ADDENDUM NO. 3 TO PROJECT NO. 44782

ELECTRICAL WORK PROVIDE FIRE ALARM AND EMERGENCY VOICE EVACUATION SYSTEM EMPIRE STATE PLAZA ALBANY, NY 12242

May 2, 2025

SHEET TITLE:
PARKING GARAGE LEVEL P1 AREA J AND K FLOOR PLAN
DRAWING NUMBER:
F-P-120
SHEET **95** OF **137**

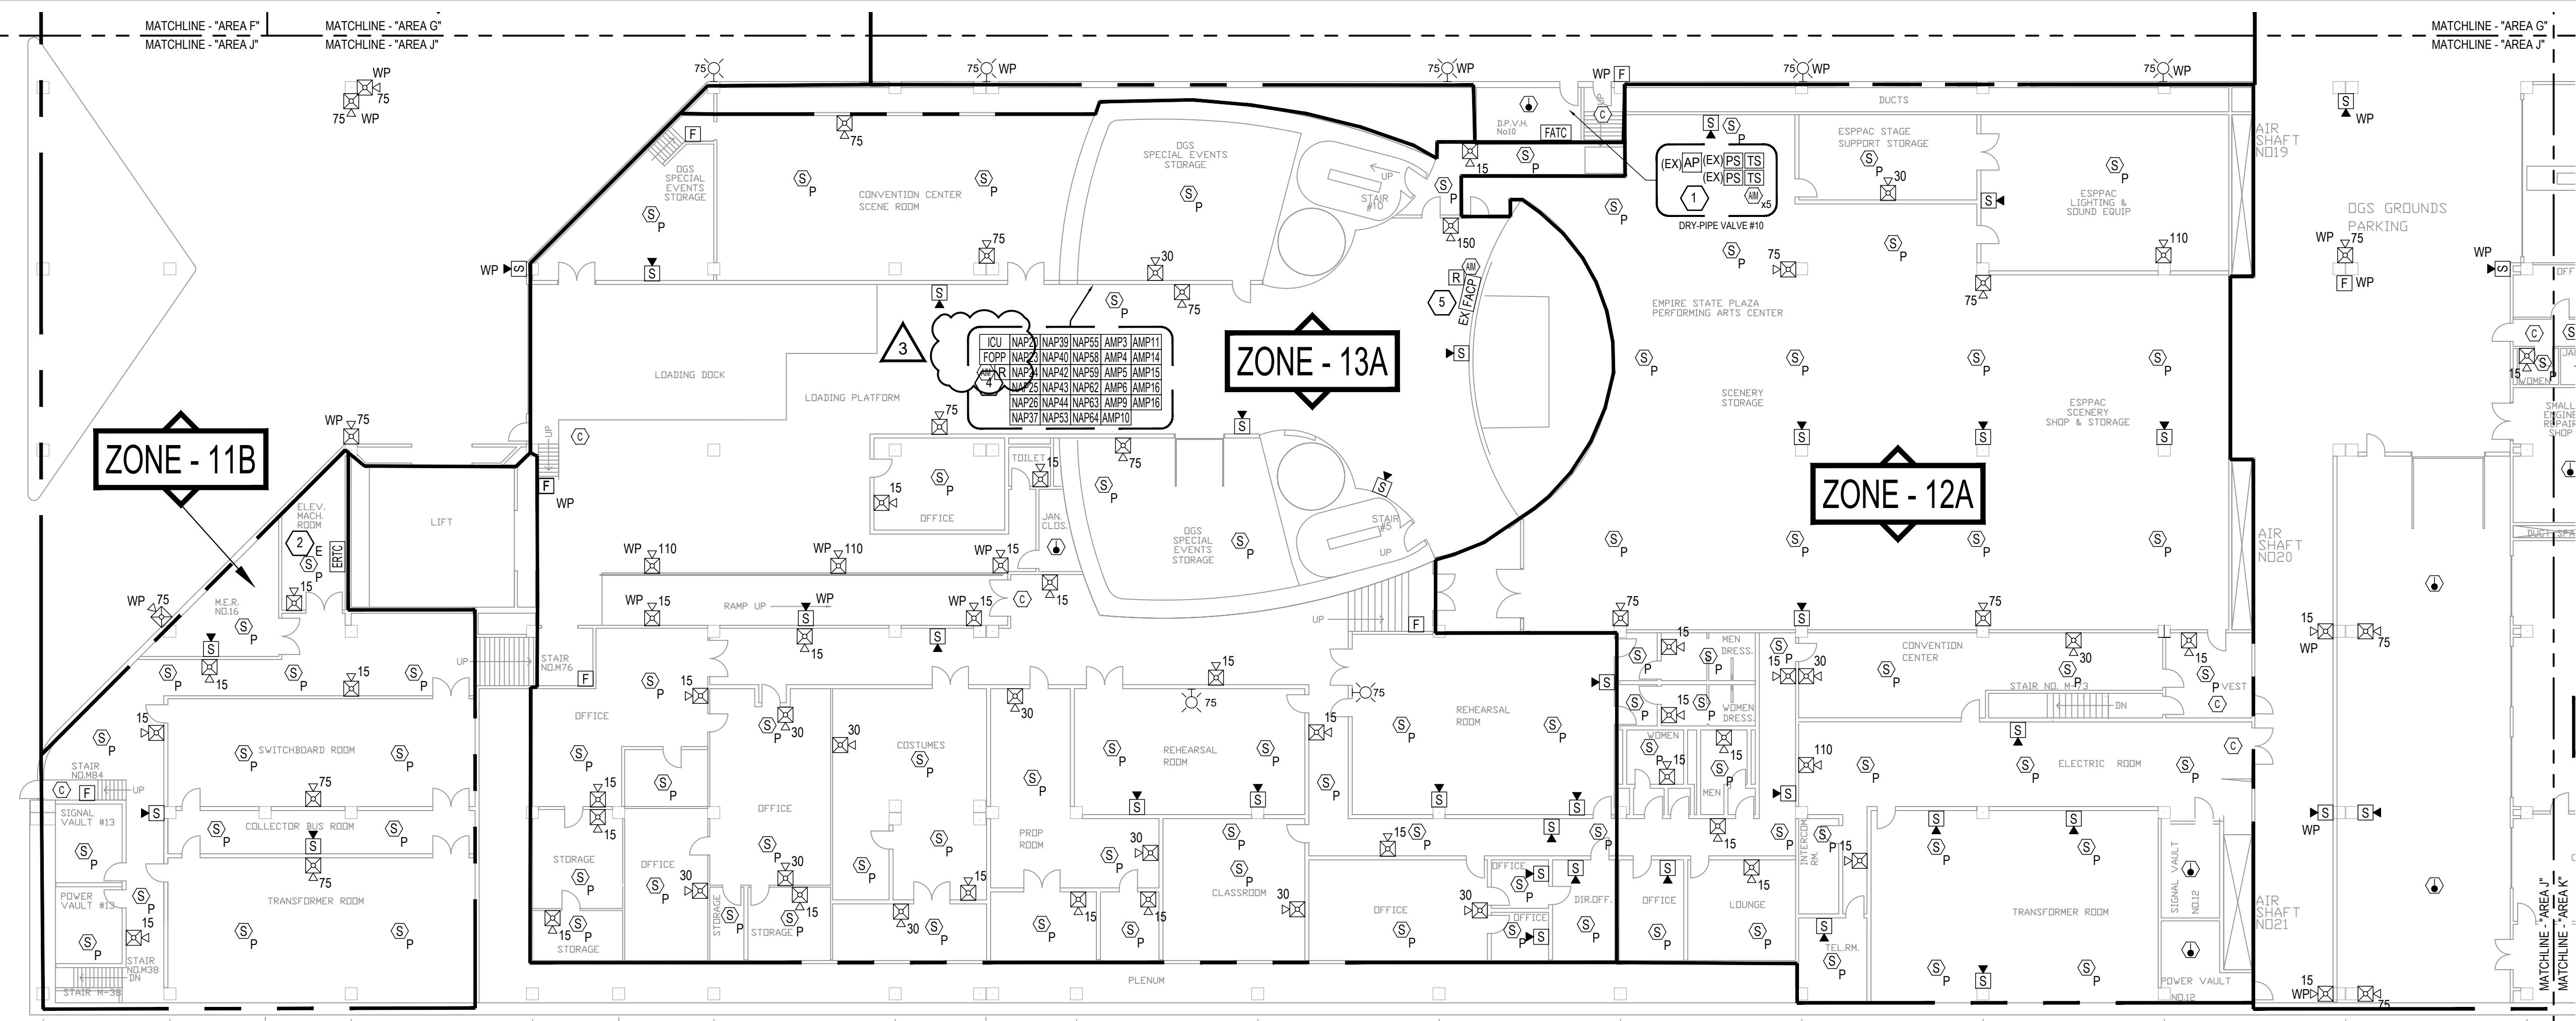
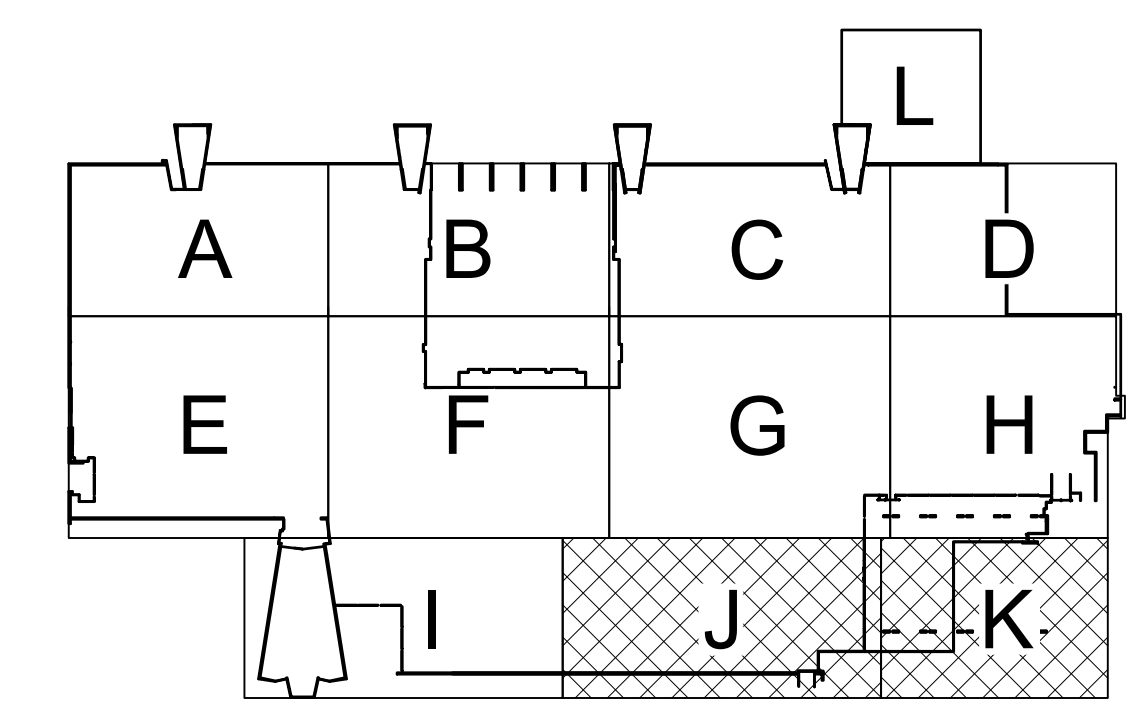
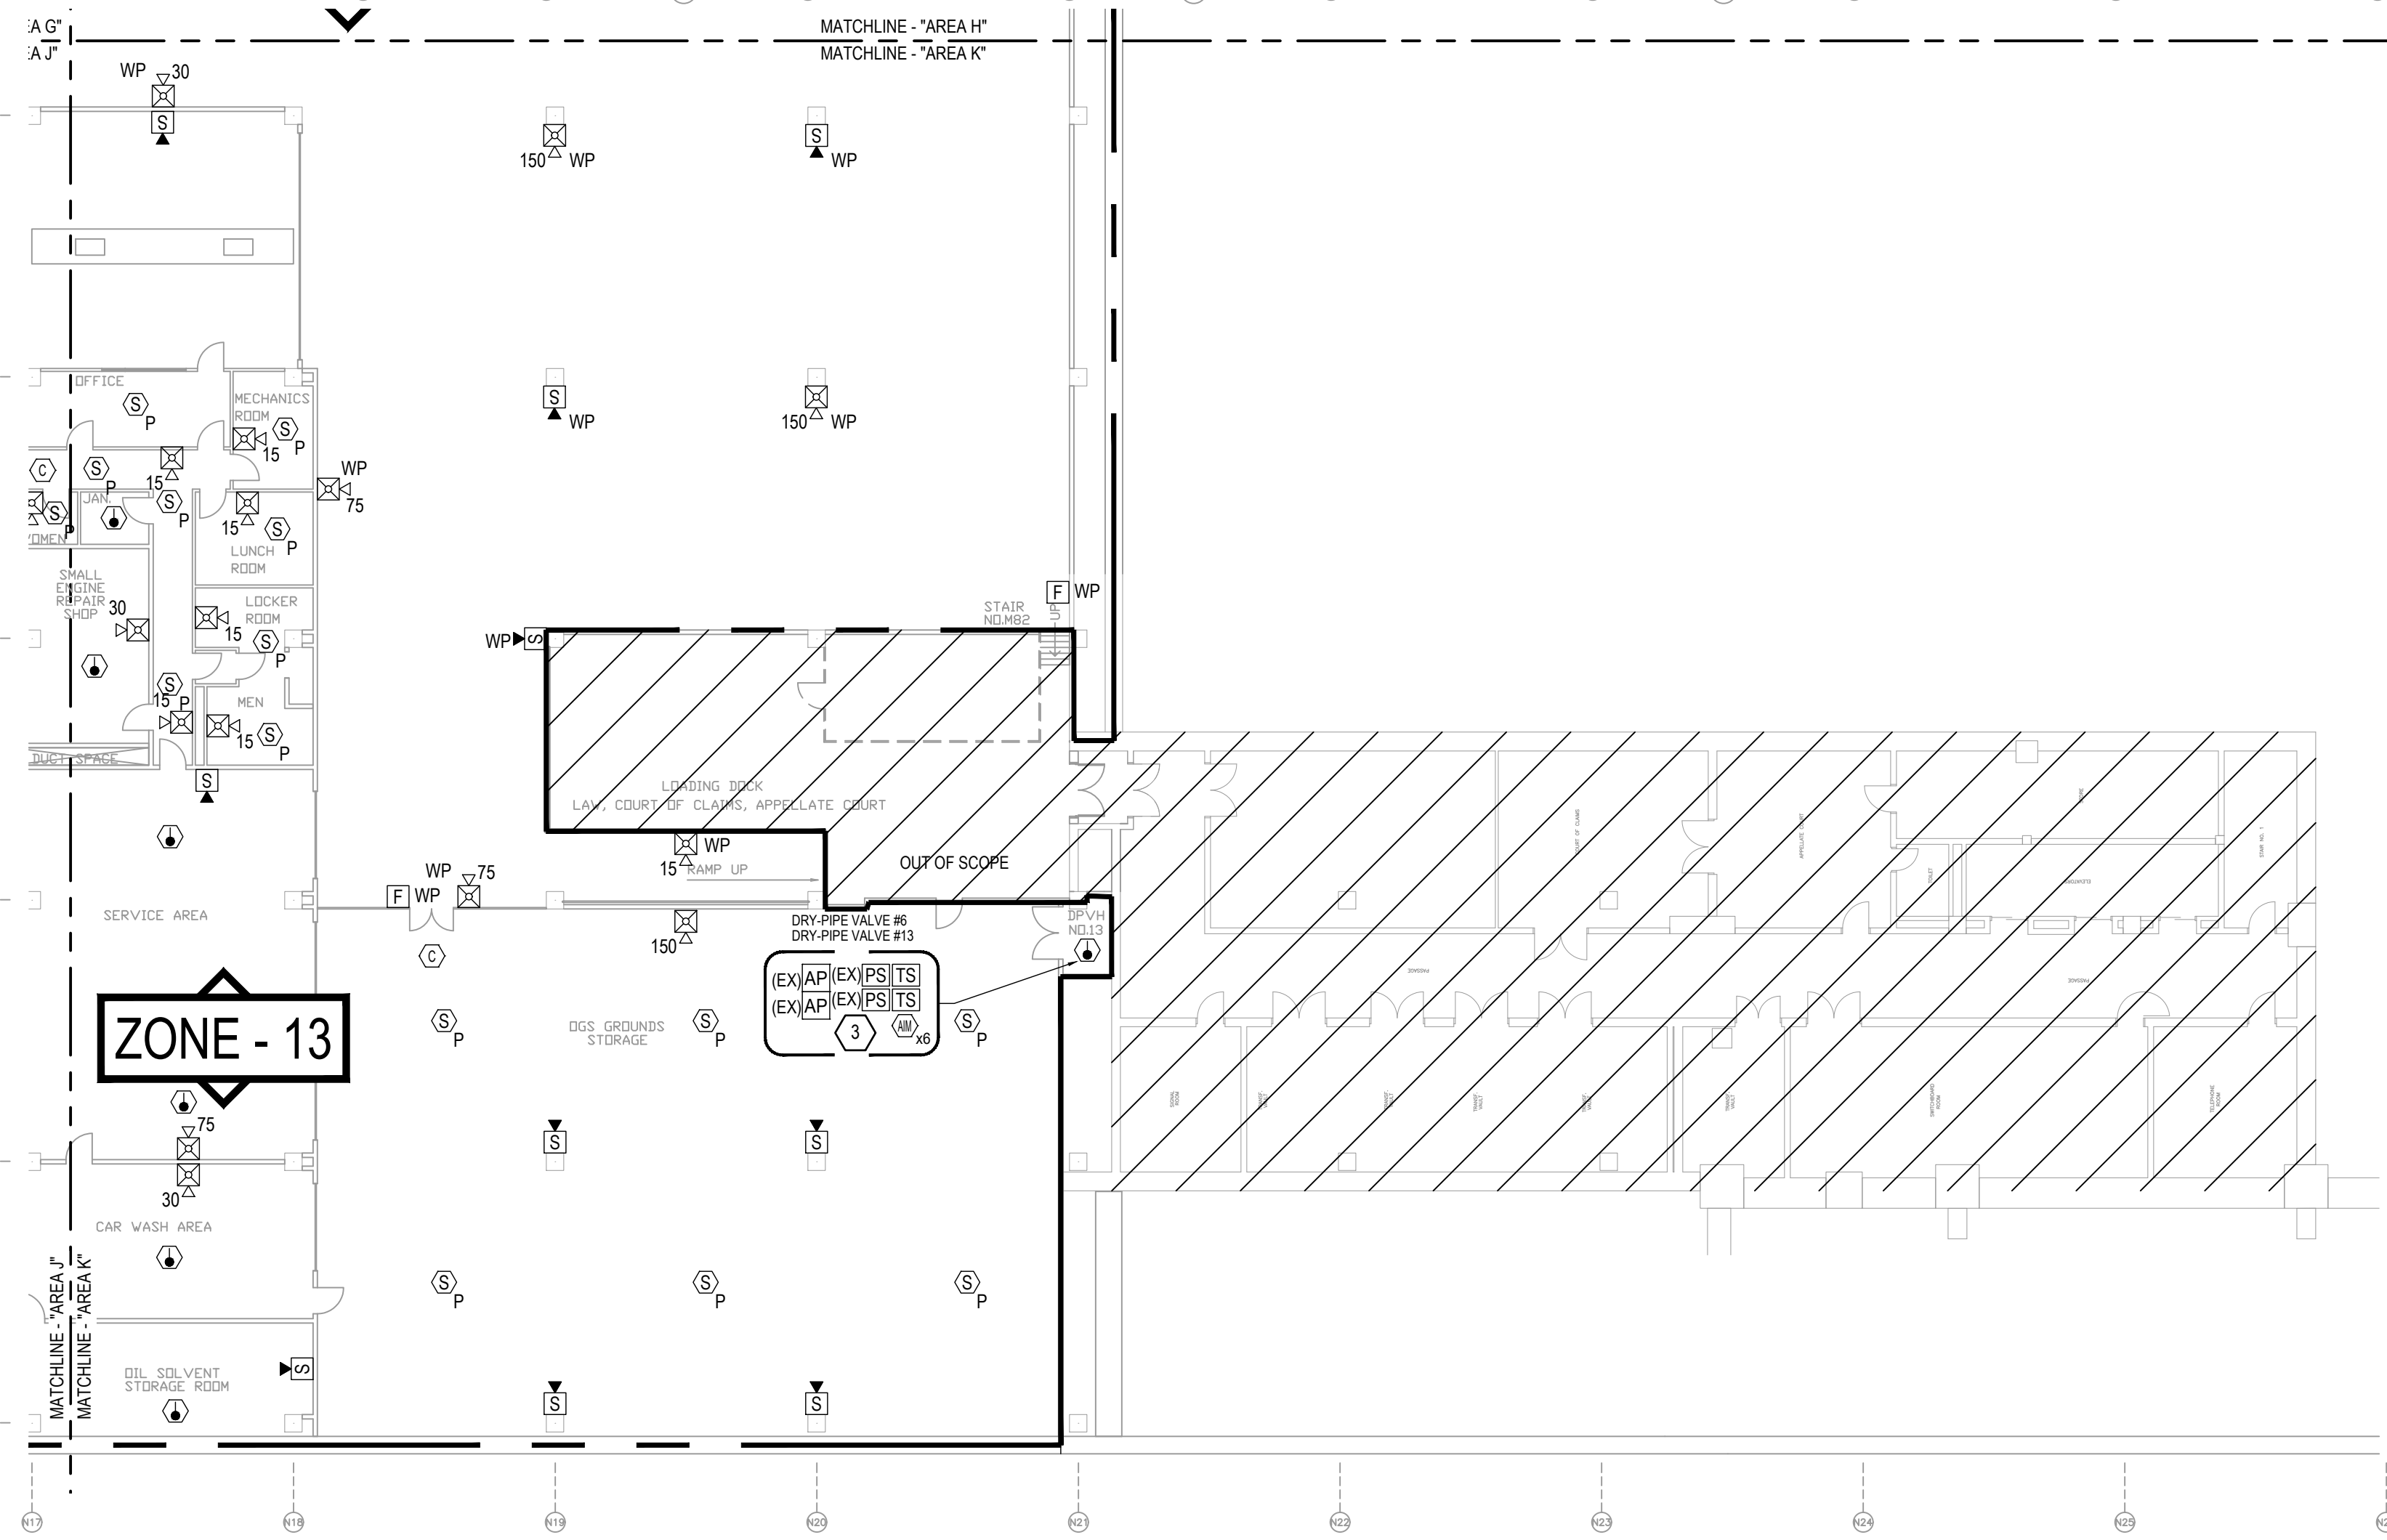
- PROVIDE TWO (2) TAMPER SWITCHES AND TWO (2) ADDRESSABLE INPUT MODULES TO MONITOR THE EXISTING SPRINKLER SYSTEM CONTROL VALVES. PROVIDE ONE (1) ADDRESSABLE INPUT MODULE TO MONITOR THE EXISTING SPRINKLER SYSTEM WATERFLOW PRESSURE SWITCH. PROVIDE TWO (2) ADDRESSABLE INPUT MODULES TO MONITOR THE EXISTING HI / LOW AIR PRESSURE SWITCHES.

- PROVIDE THREE ELEVATOR RECALL RELAYS FOR EACH ELEVATOR (PRIMARY, ALTERNATE, RED HAT).
- PROVIDE TWO (2) TAMPER SWITCHES AND TWO (2) ADDRESSABLE INPUT MODULES TO MONITOR THE EXISTING SPRINKLER SYSTEM CONTROL VALVES. PROVIDE TWO (2) ADDRESSABLE INPUT MODULES TO MONITOR THE EXISTING SPRINKLER SYSTEM WATERFLOW PRESSURE SWITCHES. PROVIDE TWO (2) ADDRESSABLE INPUT MODULES TO MONITOR THE EXISTING HI / LOW AIR PRESSURE SWITCHES.

- PROVIDE XLS-DVC WITH DVC-AO MODULE TO PROVIDE AUDIO CONNECTIVITY TO THE EXISTING XLS-1000 FACP LOCATED IN THE LOBBY OF THIS LEVEL. PROVIDE ONE ADDRESSABLE MONITOR MODULE TO ACTIVATE MESSAGING ON THE XLS-3000 FIRE ALARM SYSTEM IN THIS ZONE. PROVIDE ONE ADDRESSABLE SUPERVISED CONTROL RELAY MODULE FROM THE XLS-1000 FIRE ALARM SYSTEM TO MONITOR FOR ALARM. CONNECT WIRES FROM XLS-1000 SYSTEM TO THE CORRESPONDING AUDIO INPUT AND OUTPUT TERMINALS. PROGRAM THE XLS-DVC TO PLAY MESSAGES FROM THE XLS-1000 AUDIO SYSTEM EGG IN THE APPROPRIATE ZONES SURROUNDING THE EGG ON THE CONCOURSE, PARKING LEVEL 1, AND PARKING LEVEL 3.

- PROVIDE ONE ADDRESSABLE SUPERVISED CONTROL RELAY MODULE TO ACTIVATE THE XLS-1000 SYSTEM AND PLAY A MESSAGE IF THE XLS-3000 FIRE ALARM SYSTEM IS ACTIVELY PLAYING A MESSAGE. PROVIDE ONE ADDRESSABLE MONITOR MODULE TO MONITOR THE XLS-1000 SYSTEM FOR ALARM AND TO ACTIVATE THE XLS-3000 SYSTEM AND PLAY THE MESSAGING FROM THE XLS-1000 FIRE ALARM AUDIO SYSTEM. CONNECT WIRES FROM XLS-3000 SYSTEM TO THE CORRESPONDING AUDIO INPUT AND OUTPUT TERMINALS. PROGRAM THE XLS-1000 FIRE ALARM SYSTEM TO PLAY THE MESSAGE FROM THE XLS-3000 XLS-DVC WHENEVER AN ALARM OCCURS ON THE PLAZA LEVEL, PARKING LEVEL 1, AND PARKING LEVEL 3 NEAR THE EGG.
